AR-07-0061

Southern Nuclear Operating Company
Vogtle Early Site Permit Application
Response to Requests for Additional Information on the Environmental Report

SNC's response to the NRC environmental RAIs is provided in Enclosure 1, 2 and 3 to this letter.

Figure 1
Schematic diagram showing hydrogeologic units at the Vogtle Electric Generating Plant (VEGP) Site (Units 3 and 4) drawn from the power block area to the new intake structure (See SSAR Figures 2.4.12-3 and 2.5.4-1)

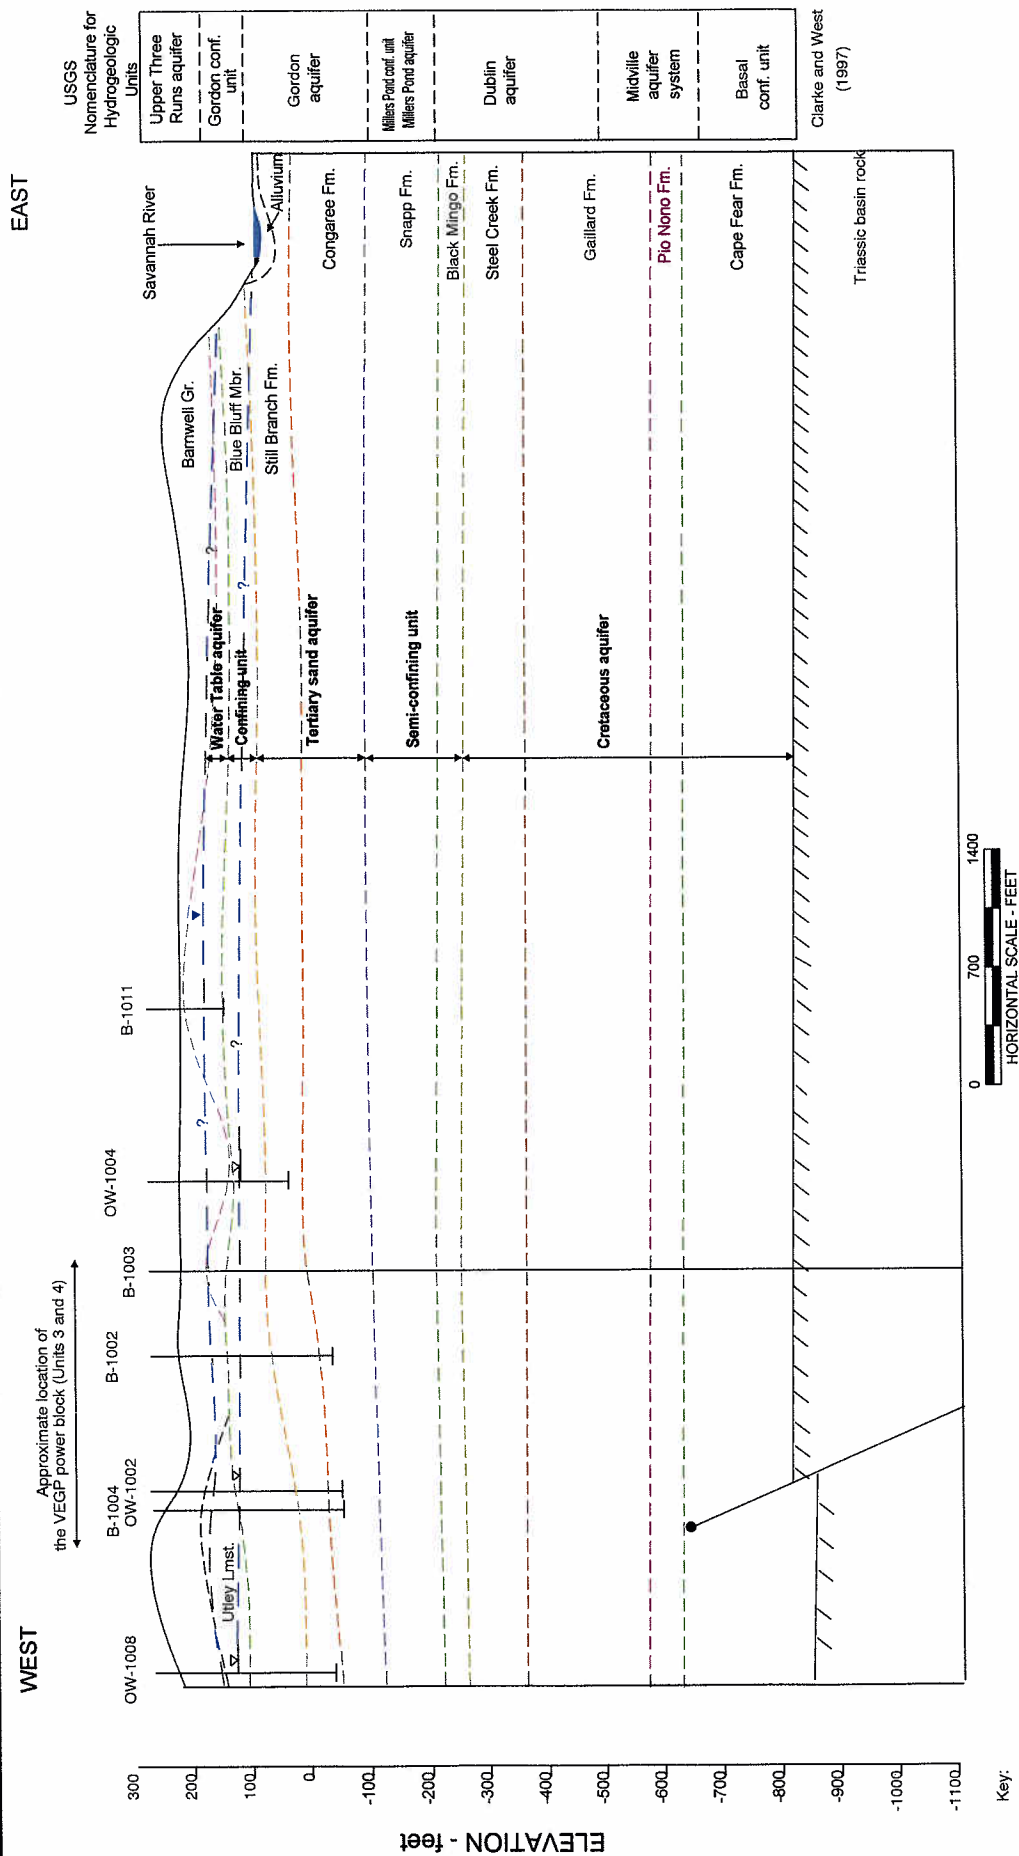
E2.3-2 Section 2.3.1.2 Groundwater Resources, Section 2.3.1.2.2 Local Hydrogeology, Section 2.3.1 -2.4 Hydrogeologic Properties Describe the process used to develop the site hydrogeologic conceptual model so that the staff can understand (a) drawdown at offsite wells, (b) impacts to and loss of wetlands, and (c) alteration of groundwater gradients and degradation of water quality from their current state. Provide a thorough description and discussion of the conceptual model(s), and how the applicant's model contrasts with the conceptual models of the VEGP Updated Final Safety Analysis Report and U.S. Geological Survey studies (Clarke and West 1997, 1996; Cherry 1996). Provide complete references and describe the datasets that the site conceptual model relies upon for calculating: (1) the water budget (e.g., precipitation, runoff, pumping); (2) monitoring of well water levels during construction of VEGP Units 1 and 2; (3) tritium observed in the unconfined aquifer; (4) tritium observed in the confined aquifers; (5) trans-river flow; (6) changes in the near-field subsurface conceptual model due to changes in recharge, fill material, and embedded structures; (7) continuity of the Utley Limestone; (8) continuity of the Blue Bluff Marl with respect to data from wells OW-1 001/1001A (screened at water table aquifer elevation, but with measured hydraulic head values more consistent with the Tertiary aquifer); and (9) evidence indicating that the Tertiary and Cretaceous aquifers are highly isolated in light of the potential for the Pen Branch Fault to offset the hydrologic units. This description and discussion of the conceptual model should discuss hydraulic connection of the hydrologic units to the Savannah River through river alluvium, and the location and role (e.g., conduit or barrier for transport) of the Pen Branch fault.

Section 2.5.1.2.2.1.1 of the UFSAR for VEGP Units 1 and 2 indicates that the Blue Bluff marl is a distinct unit that is relatively constant in thickness over many square miles, although variable in lithology. Contours of the upper and lower surfaces as well as an isopach map of the marl in the vicinity of the plant are shown on drawings AX6DD352, AX6DD371, and AX6DD372 of the UFSAR. These drawings indicate the Blue Bluff Marl to be continuous over the entire VEGP site. On the VEGP site, the ESP subsurface investigation (SSAR Appendix 2.5A) determined that the Blue Bluff Marl ranges in thickness from 63 to 95 ft at three locations where the stratum was fully penetrated, with an average thickness of 76 ft and a median thickness of 69 ft.

With respect to data from wells OW-1001/1001A (screened within the Water Table aquifer, but with measured hydraulic head values appearing to be more consistent with the Tertiary aquifer), further review of boring logs, well construction logs, and water levels for both wells indicates that water levels recorded in these wells are invalid. Response to RAI E2.3-3 provides the basis of this conclusion. Given these results and considering that the Blue Bluff Marl was encountered in deeper borings in the vicinity of wells OW-1001/1001A, there is no evidence suggesting that the Blue Bluff Marl is absent or discontinuous at this location.

SSAR Section 2.5.1.2.4 describes previous investigations of the Pen Branch fault and the site subsurface investigation of the fault that was conducted for the ESP application. Results of this investigation, which included seismic reflection and refraction surveys, clearly document that the Pen Branch fault strikes northeast and dips southeast beneath the VEGP site. SSAR Figure 2.5.1-42 shows the vertical projection of the Pen Branch fault from the top of basement rock in relation to VEGP Units 3 and 4. The plan projection of the intersection of the Pen Branch fault with the top of basement rock is located beneath or slightly southeast of the antiformal hinge at the top of the monocline in the Blue Bluff Marl (SSAR Figure 2.5.1-39). Because of its spatial association with the Pen Branch fault, it is likely that this monocline feature is the result of reverse or reverse-oblique slip on the Pen Branch fault. The seismic survey data further indicate that the fault terminates in the Cretaceous Coastal Plain deposits. Overlying Tertiary deposits, including those comprising the Gordon (Tertiary sand) aquifer, Gordon aquitard (Blue Bluff Marl), and Upper Three Runs (Water Table) aquifer, are therefore not affected by the Pen Branch fault. This result is consistent with that of Summerour et al. (1998), who reported that none of the faults identified in their seismic surveys appear to have disturbed the Gordon aquitard (Blue Bluff Marl), which isolates the unconfined aquifer from underlying confined aquifers.

FIGURE 1.0 PLAN-RIVERFRONT STRUCTURES

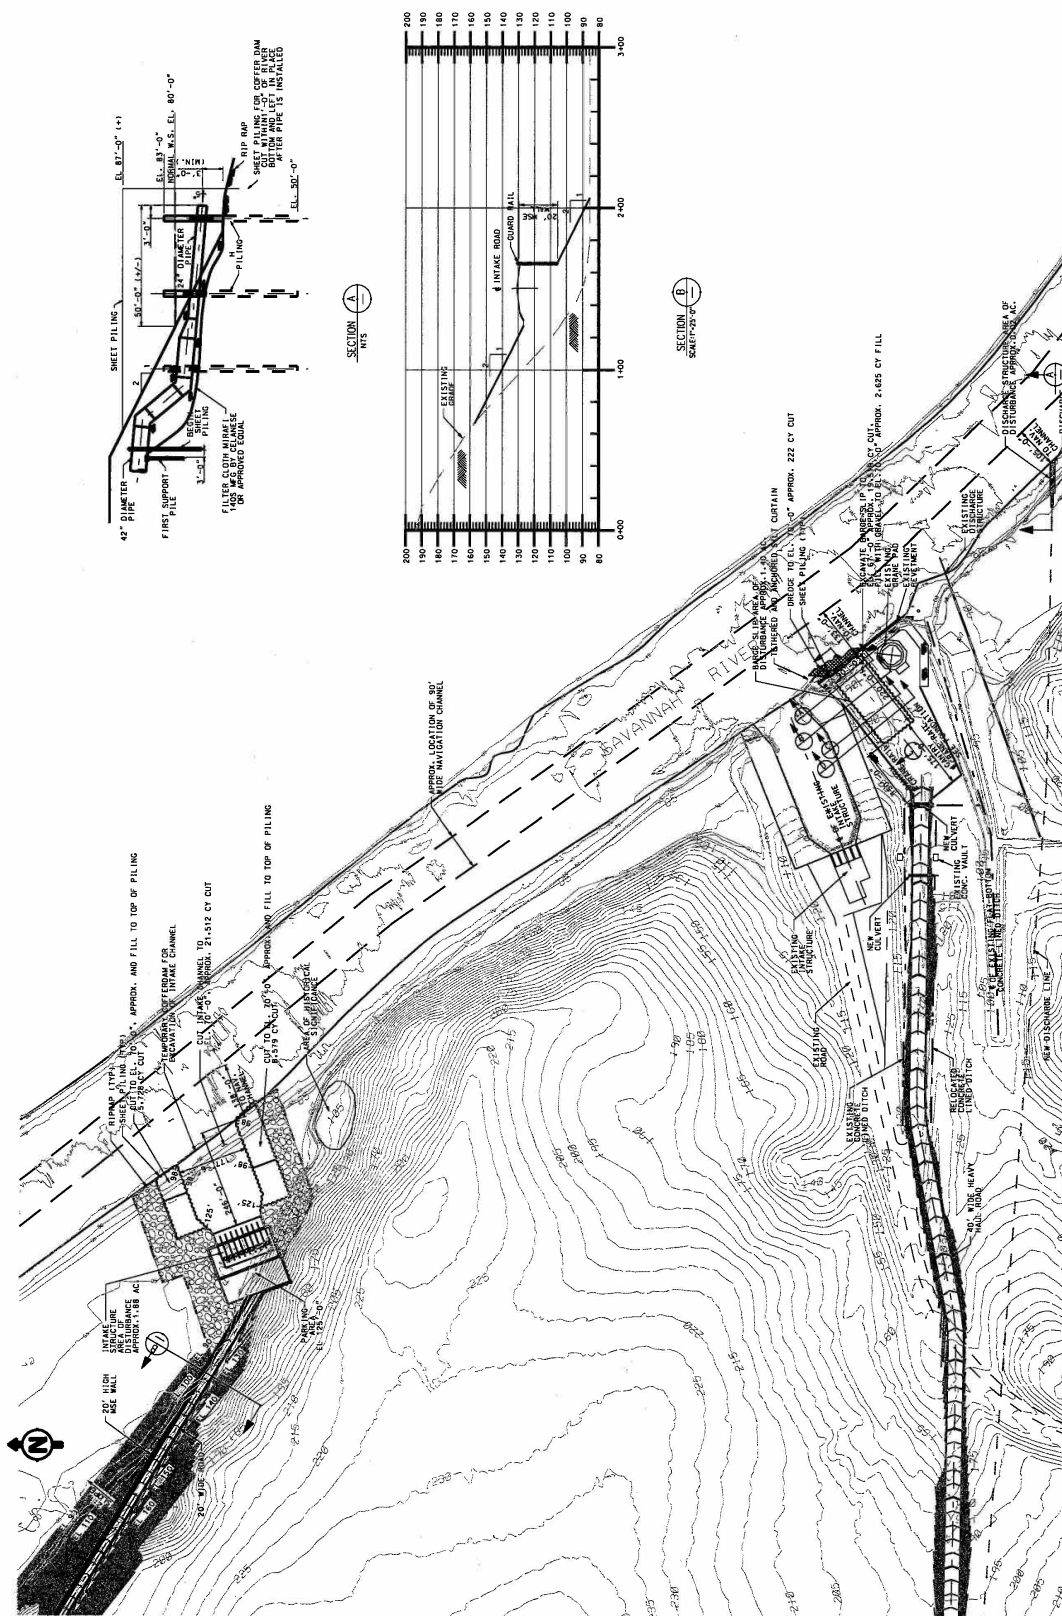
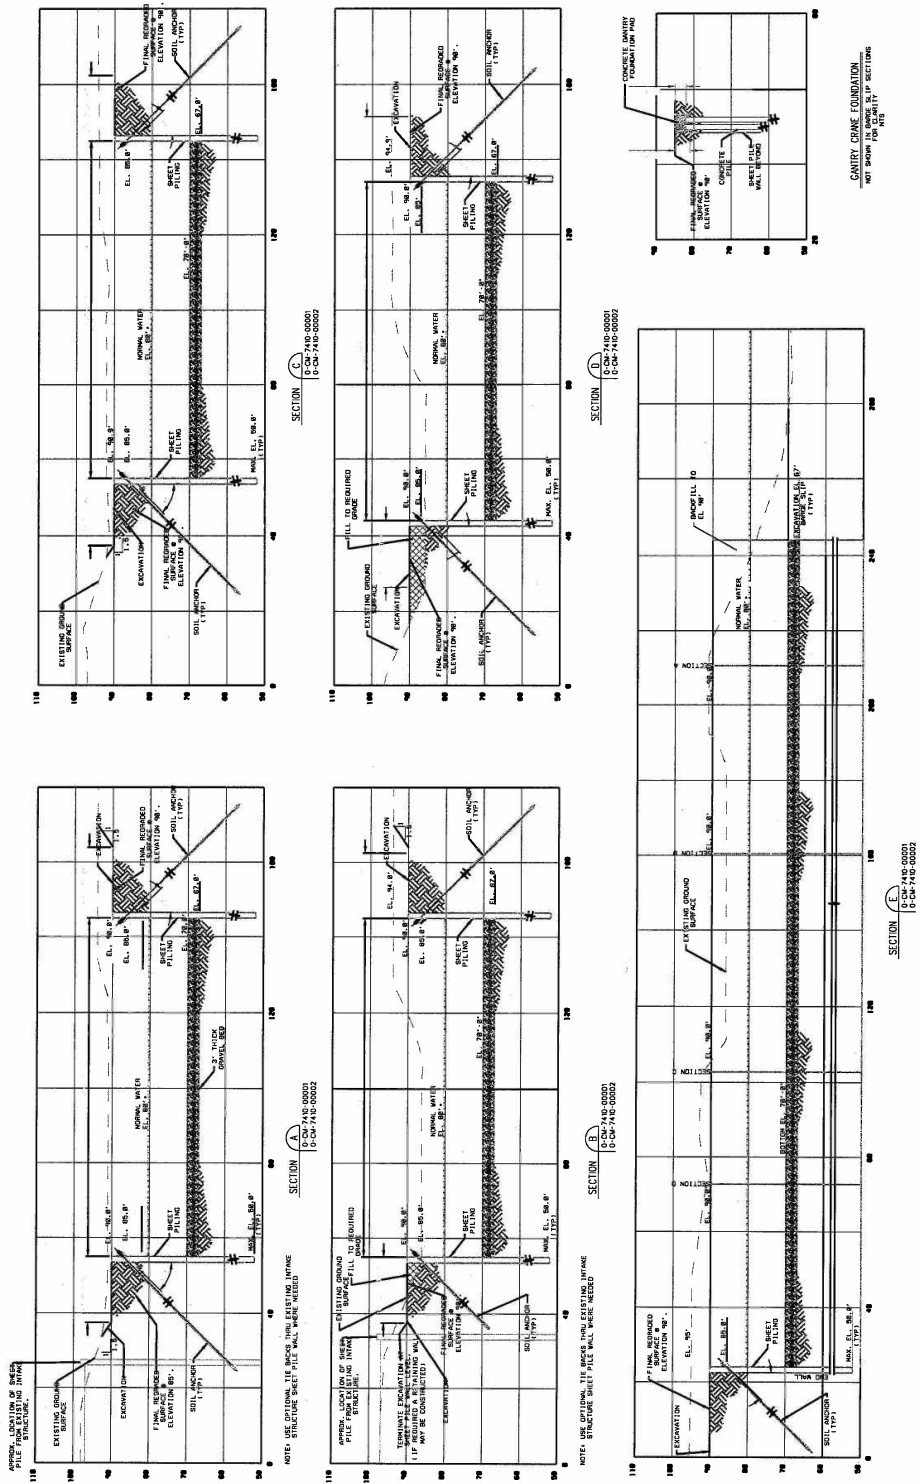
E3.9-4 Sections 3.9.2.9 Docking and Unloading Facilities Installation and 3.9.2.10 Intake/Discharge Cofferdams and Piling Installation and other portions of 3.9.2 Provide a description of the construction process that may be used for projects that may require a 404 permit. There is currently insufficient detail to determine whether there would be any dredge and fill activities associated with the pre-construction activities, including building access roads to and from riverfront structures, the new cooling water intake structure, the new discharge structure, modification of existing barge slip, and installation of proposed 500-kV transmission line. Provide information regarding the pre-construction activities that would have a dredge-and-fill component. Provide information on the quantities of material to be dredged and where these spoils will be placed. Discuss any sediment characterization that would be conducted on the dredged material.

E3.9-5 Section 3.9.2.9 Docking and Unloading Facilities Installation, The ER states that "The existing barge slip must be enlarged to support unloading the AP1000 components and modules. The downstream sheet pile wall must be removed and the slip must be excavated to the correct dimensions. The downstream sheet pile wall will be reconstructed and the shore line stabilized prior to use." Provide a map of the site and vicinity delineating the areas of construction and indicate where the actual structure would be located. Provide the proposed construction activity schedule. Provide plan and section views of the new/expanded barge slip, If dredging is involved, identify the areal extent of dredging, the depth of dredging, and the volume of dredged material. Describe any fill material and the volume of material to be placed below the ordinary high water (OHW) level line.

E3.9-7 Section 3.9.2.10 - Intake/Discharge Cofferdams and Piling Installation In addition to the information provided on Figures 3.4-2 and 3.4-4 for the new intake and discharge structures, provide the following information: 1) Distance from intake structure and discharge structure to Federal navigation channel; 2) Dimensions of all fill to be used in the Savannah River (including backfill and temporary fill for structures such as cofferdams and access roads); 3) Describe fill materials and number of cubic yards to be placed below the OHW level line; and 4) If dredged material is involved, show the extent of dredging, describe the type of material, number of cubic yards, and method of handling.

New Barge Slip Design: As shown on Figure 1 of this RAI, the Barge Slip is located between the existing Units 1 and 2 intake canal, and the existing ring crane foundation. The barge slip would be excavated from the existing west side shoreline landward for a distance of 220'. The width of the barge slip would be 90'. The channel's side slopes and landward slope would be retained by vertical sheet pile walls. The finished depth below water surface would be about 10'. The excavation will be three feet deeper than the finished bottom to allow for placement of a bedding zone of gravel. The transport barges will be maneuvered into the channel with river tugs and either (1) moored to dolphins or bollards or, (2) sunk by ballasting such that the barge is founded on the gravel bedding zone.

Discharge Structure Design: As shown in Section A of E3.9 Figure 1, the new Discharge Structure will consist of a 42 inch diameter steel pipe, that is reduced to a 24 inch diameter steel pipe at the point of discharge. The preliminary centerline elevation of the discharge pipe is approximately 3 feet above the Savannah River bottom elevation. Riprap will be placed around the discharge point to resist potential bottom scour due to the discharge jet from the pipe.

E3.9 Figure 1 provides a detailed plan the proposed location of the new Barge Slip to support construction of Units 3 and 4. The slip is located southeast of the existing River Intake Structure for Units 1 and 2, and northwest of the existing Barge Unloading Facility. The proposed construction activity schedule for the new Barge Slip would begin upon the issuance of the Early Site Permit (ESP), Limited Work Authorization (LWA), and other necessary permits.

E3.9 Figures 1 and 2 provide the plan and section views of the new barge slip, providing proposed slip dimensions, required, cut, fill, and dredging quantities, and generic construction material details.

Construction of the new barge slip will require approximately 300 yd³ (the quantity could be different at the time of construction) of soil to be dredged from the bed of the Savannah River as part of the formation of the east end (river interface) barge slip envelope. The depth of the dredging is to approximately Elevation 67' msl, with the boundaries of the area to be dredged shown in E3.9 Figure 1.

As shown on ER Figure 3.1-4, the estimated total area of disturbance for construction of the new Intake Structure and the new Barge Slip/Discharge Structure is approximately 12.5 acres and 10.3 acres, respectively. Refer to E3.9 Figure 1 for a breakdown of the areas of disturbance and sizes of specific portions of the structures.

As shown on E3.9 Figure 1, the sloped areas adjoining the Intake Structure will be covered with rip rap for protection during high water.

The navigation channel is 90' wide and shown on E3.9 Figure 1. The minimum distance from the westernmost edge of the navigation channel is approximately 138' for the Intake Structure and approximately 105' for the Discharge Structure.

Refer to E3.9 Figure 1 for the boundaries of the dredging from the riverbed in support of construction of the Intake Structure and the Discharge Structure.

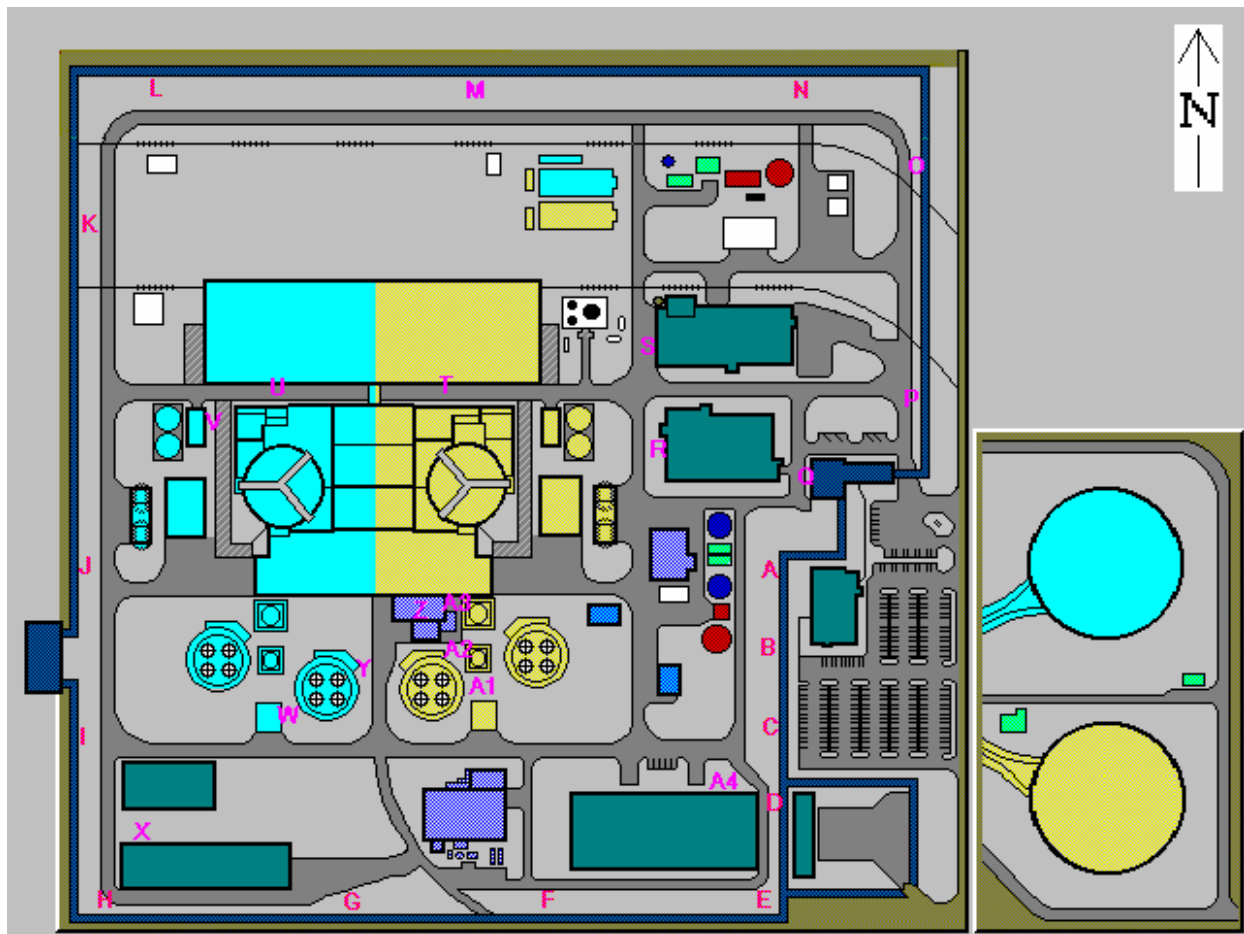
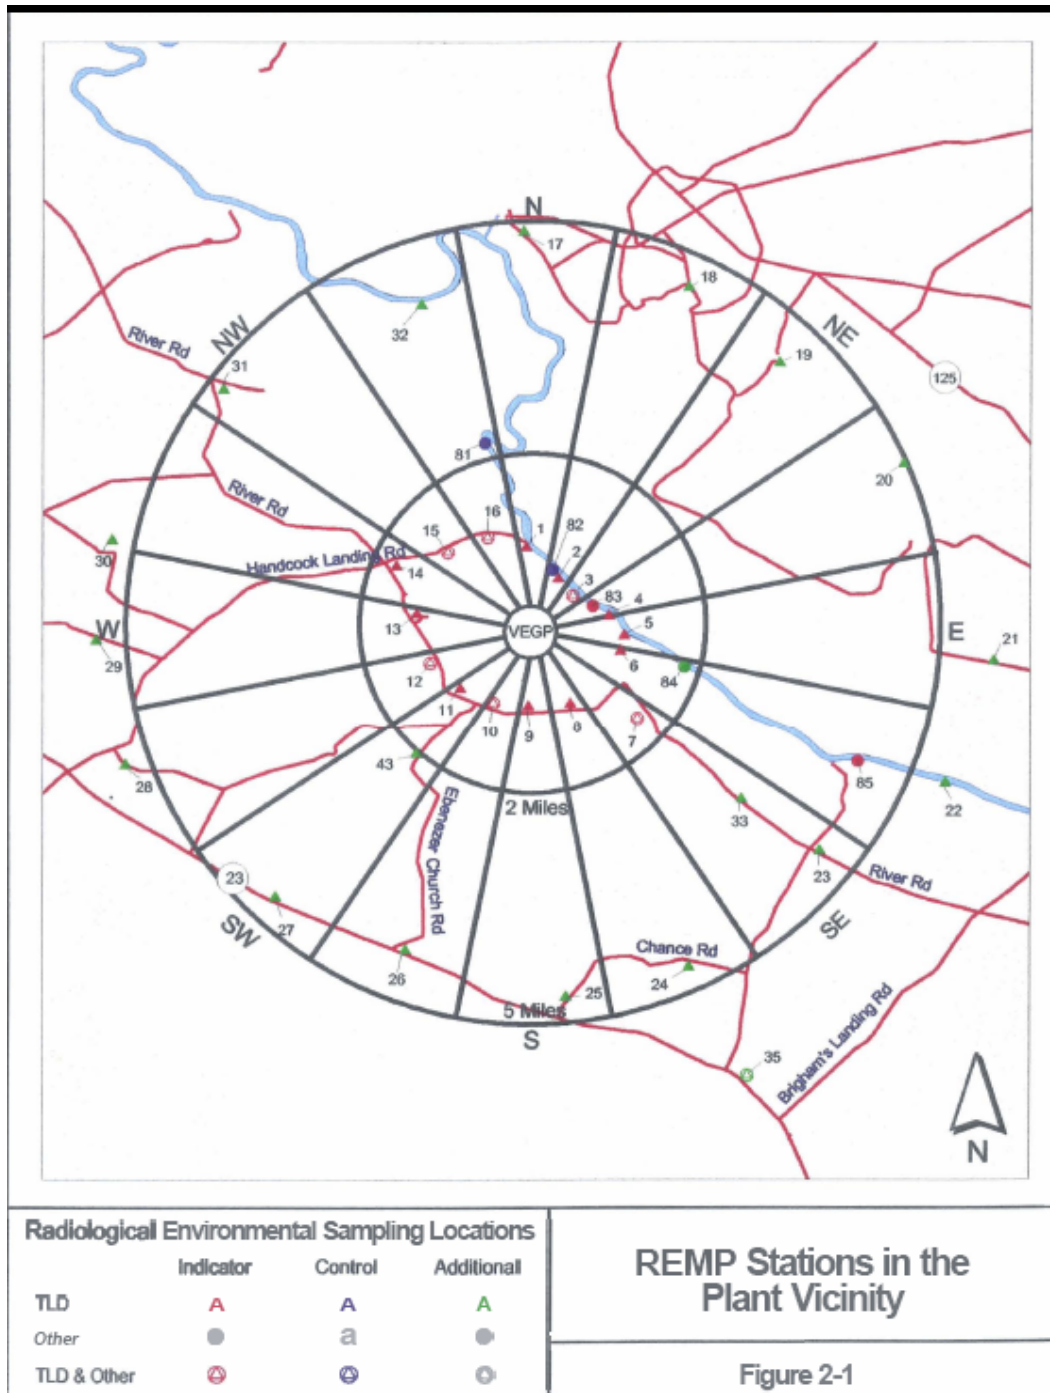
E4.5-1 Section 4.5 Radiation Exposure to Construction Workers Provide a site map indicating the location of the internal and general area TLD's used to estimate the annual direct radiation dose to the construction workforce of 50 mrem which is listed in Section 4.5.3.1 of the ER.

Following is a site map indicating the location of the TLD's used to determine the dose estimate at the Protected Area Fence closest to the construction site at VEGP Units 1 & 2. The TLD's used to determine this dose estimate are at Stations G, H, I, J, K and L.

Following is a site map indicating the location of the TLD's used to determine the background dose estimate. The TLD's used to determine the background dose estimate were inner-ring Stations 1-16.
